**DESCRIPTION:** Addendum Number 1 to the Risk Management Plan

**ADDENDUM NUMBER 1  
TO THE FINAL  
RISK MANAGEMENT PLAN FOR  
THE 64<sup>TH</sup> STREET PROPERTIES  
EMERYVILLE, CALIFORNIA**

Subject: Addendum Number 1 to the Risk Management Plan  
64<sup>th</sup> Street Properties, Emeryville, California  
(EKI 990016.03/A00084.00)

Area A Landscape Areas

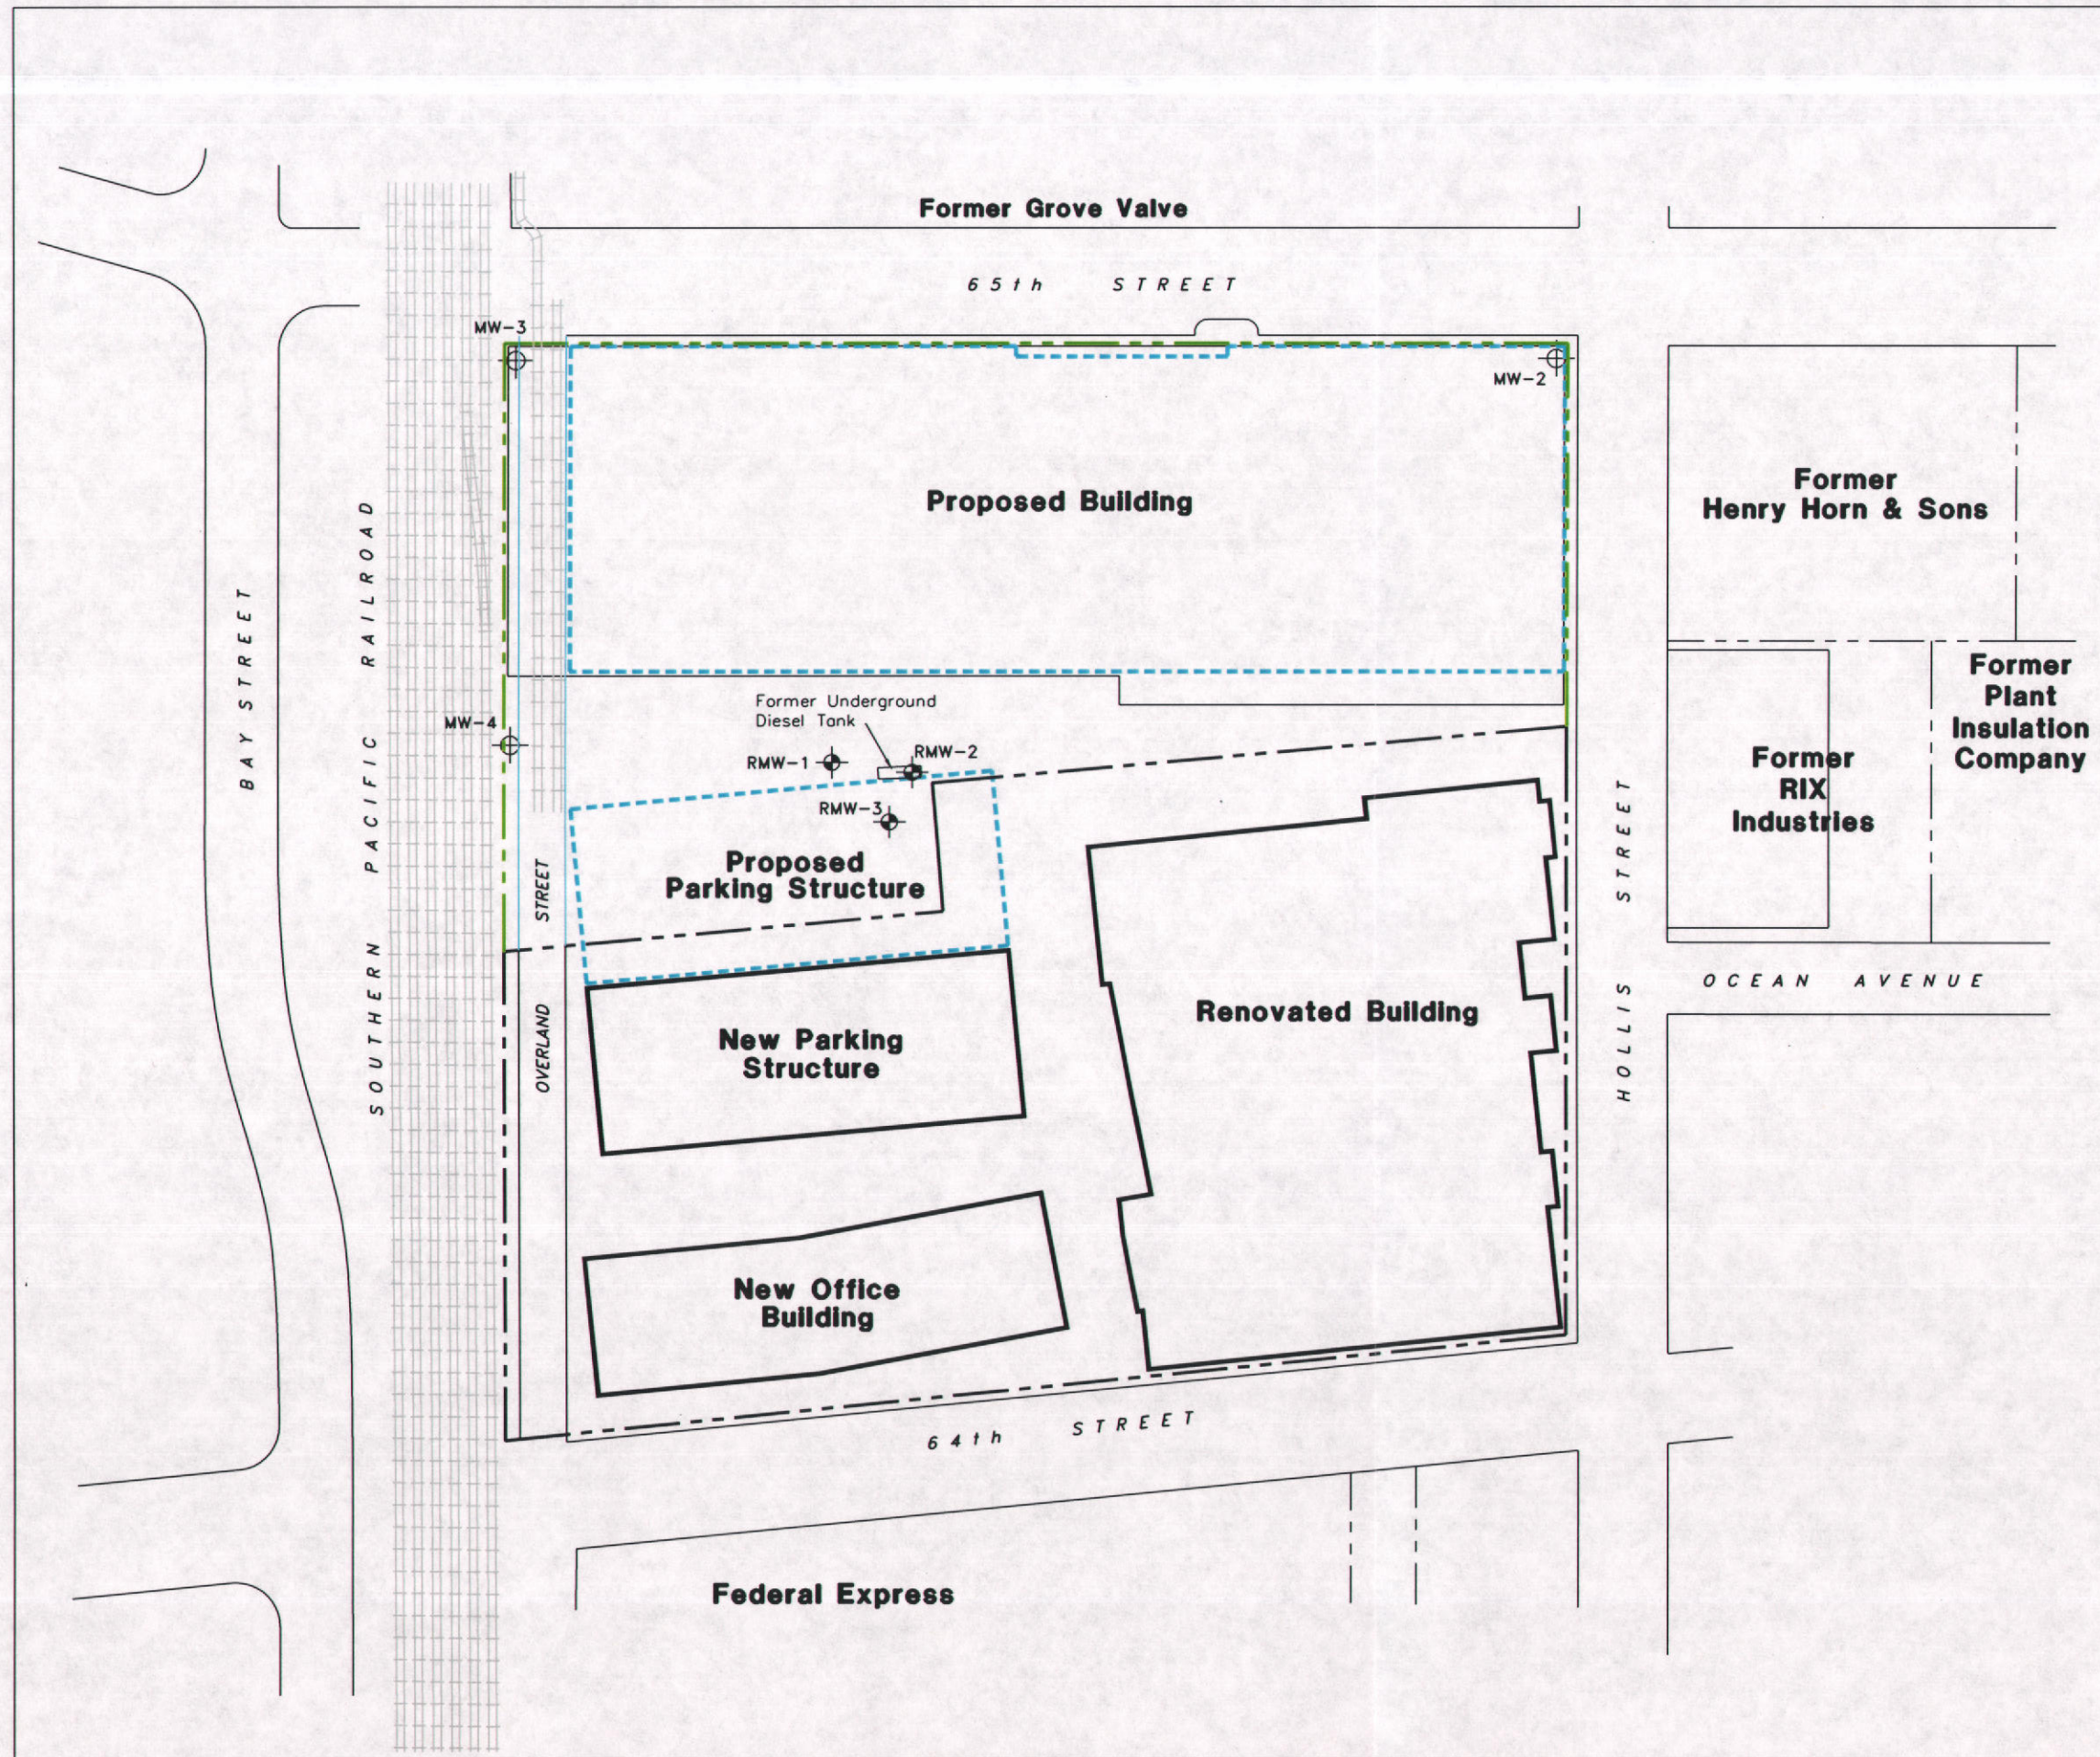
Due to sloping requirements to prevent undermining building foundations and sidewalks, a portion of the landscape areas south of the new building did not achieve the three feet of clean soil cover specified in the RMP. The landscape area of concern is shown on Figure 4. Within this landscape area, the clean soil cover near the edge (i.e., adjacent to the sidewalk and the building) ranges from 1 to 3 feet in thickness. The width of the soil cover less than 3 feet thick is approximately 2 feet. The clean soil cover thickness varies in a roughly linear fashion, with the thinnest portion being closest to the building and sidewalk. To provide a visual warning of the clean fill boundary, the bottom of the clean fill is marked with plastic, orange fence material in the areas where the clean soil cover is less than 3 feet thick.

Overlay of Conceptual Plans  
on Current Ryerson Property

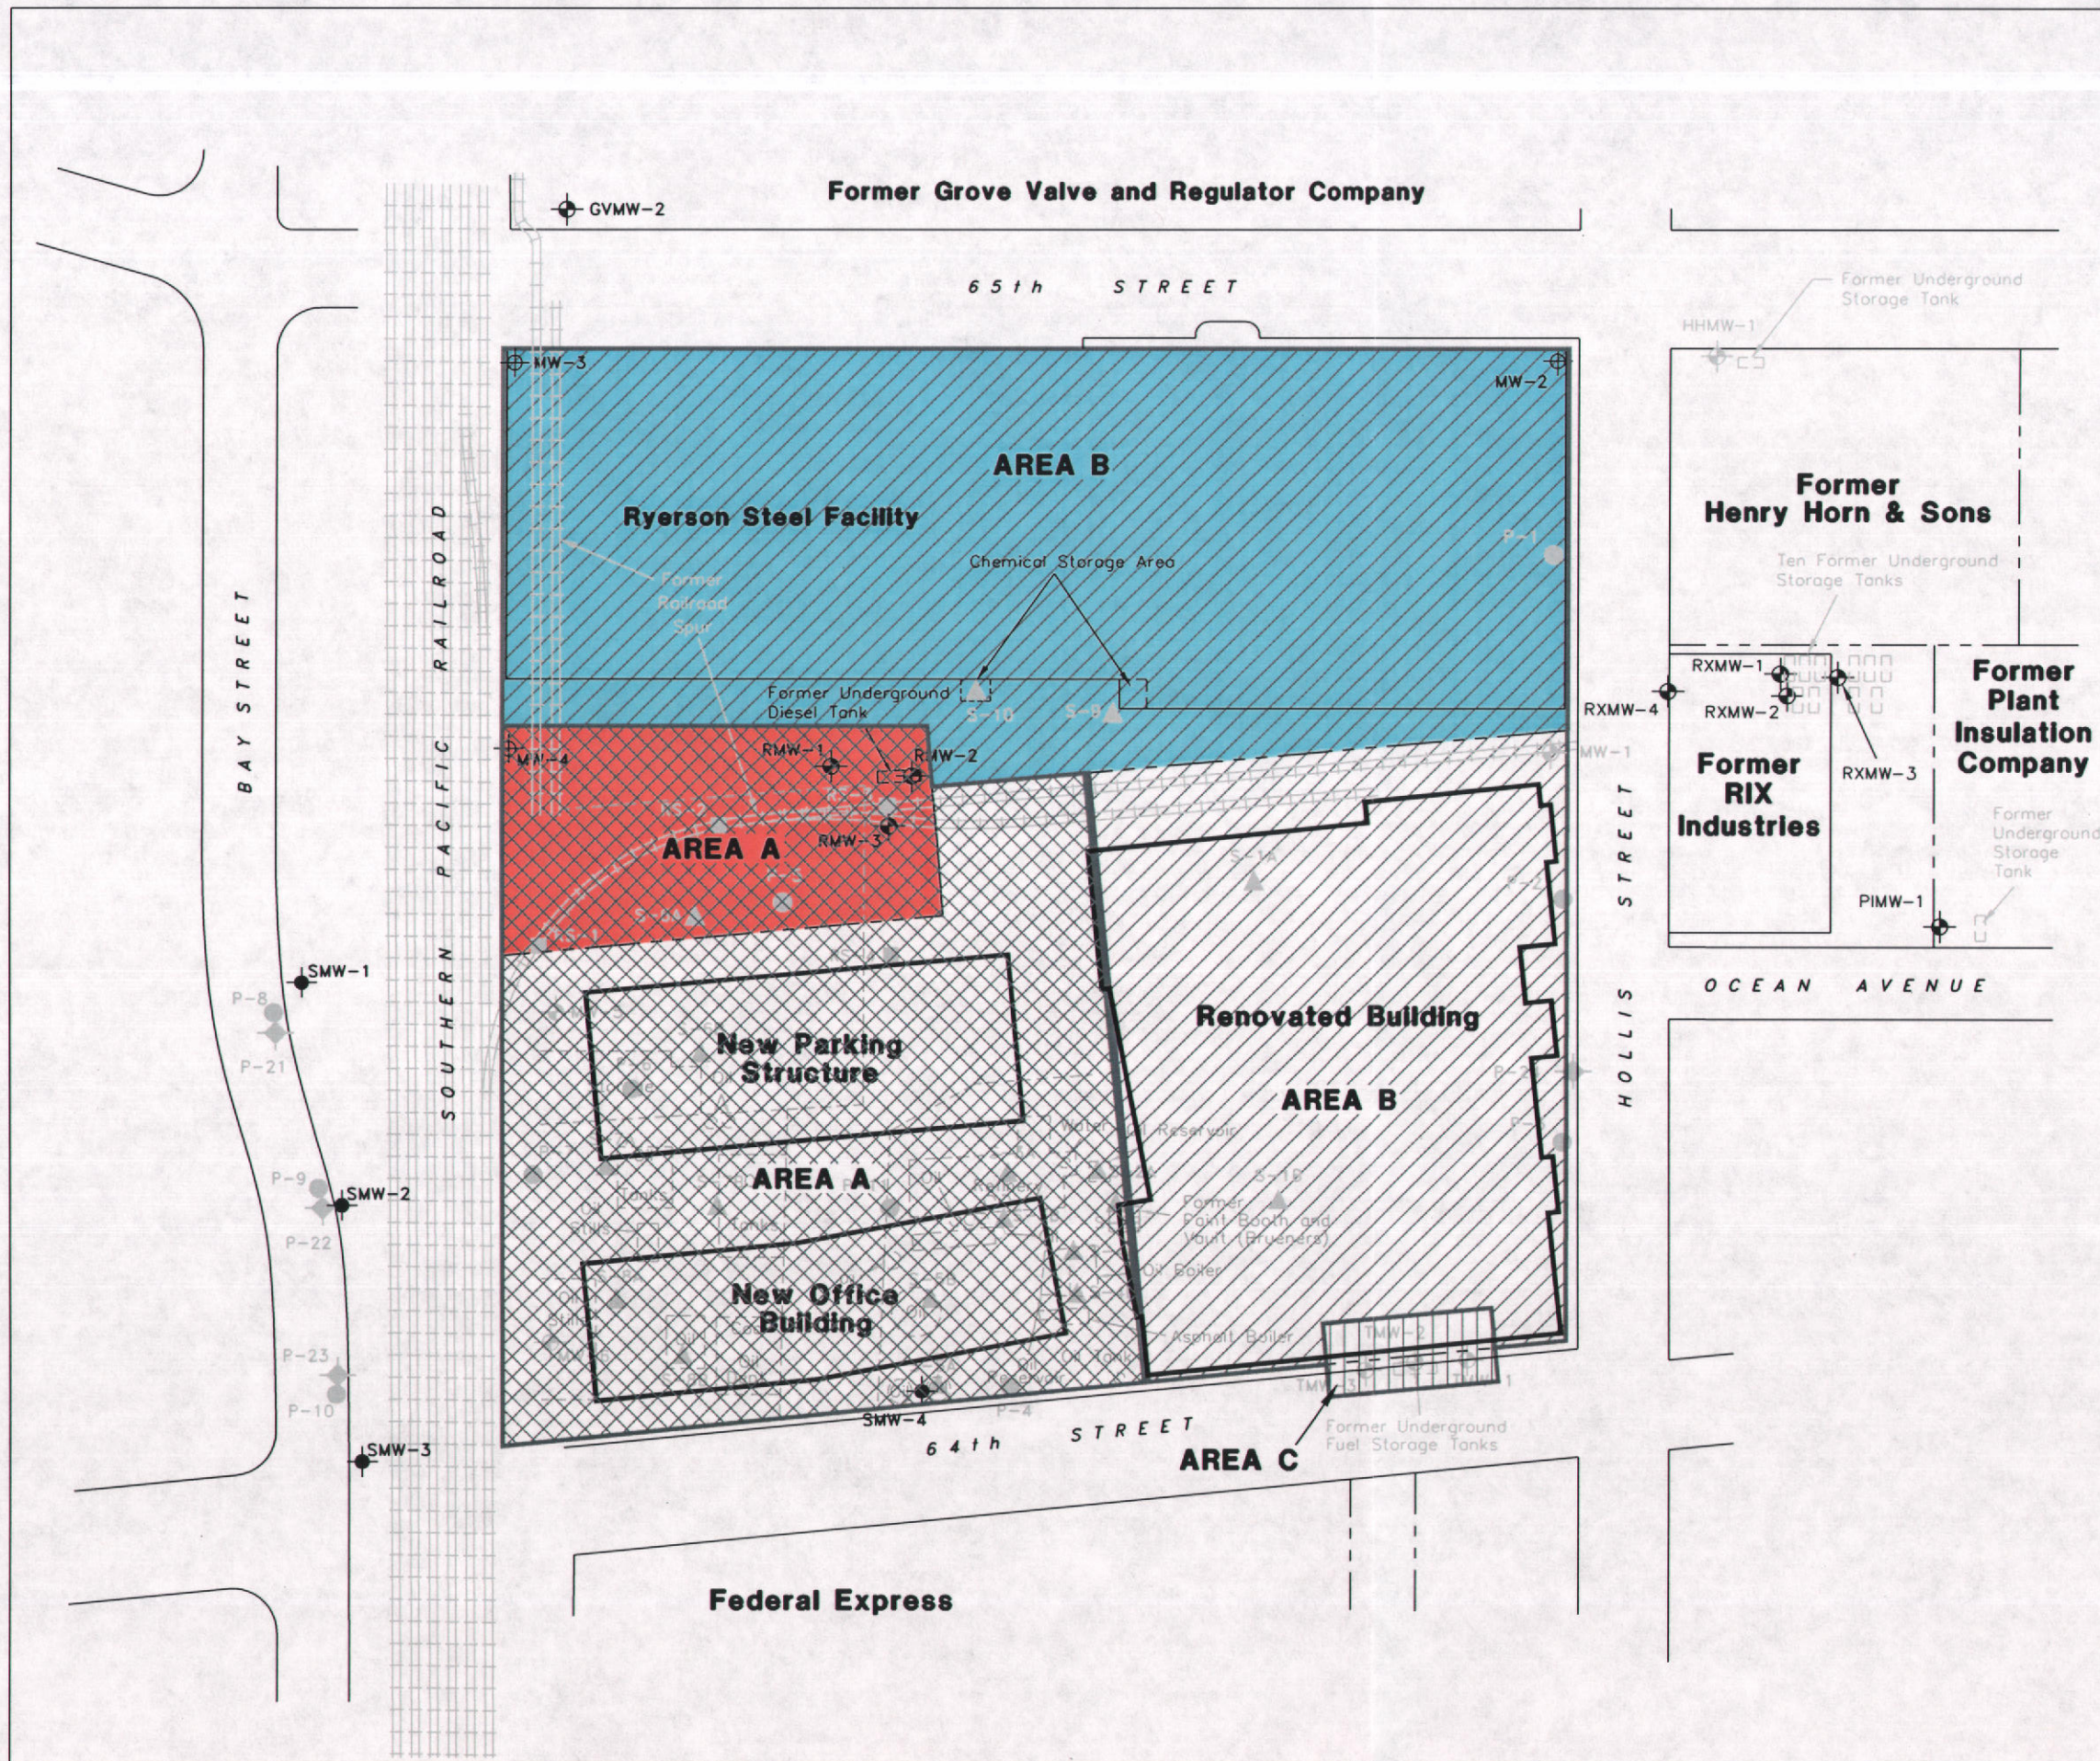
On 11 March 1993, a 10,000-gallon underground diesel storage tank was removed from the south central portion of the Ryerson property (see Figure 5) (EKI, 1999a). Shallow groundwater from a well immediately south of the tank (well RMW-3) was found to be impacted by extractable petroleum hydrocarbons, and a hydrocarbon sheen was noted in that well.

SIMEON's current planned redevelopment for the Ryerson property includes (1) renovation of the existing building for office, commercial, and/or industrial use, and (2) construction of a multi-story parking structure. A conceptual plan for the Ryerson property is shown on Figure 5. Plans for the commercial building are still preliminary and will likely be finalized next year.
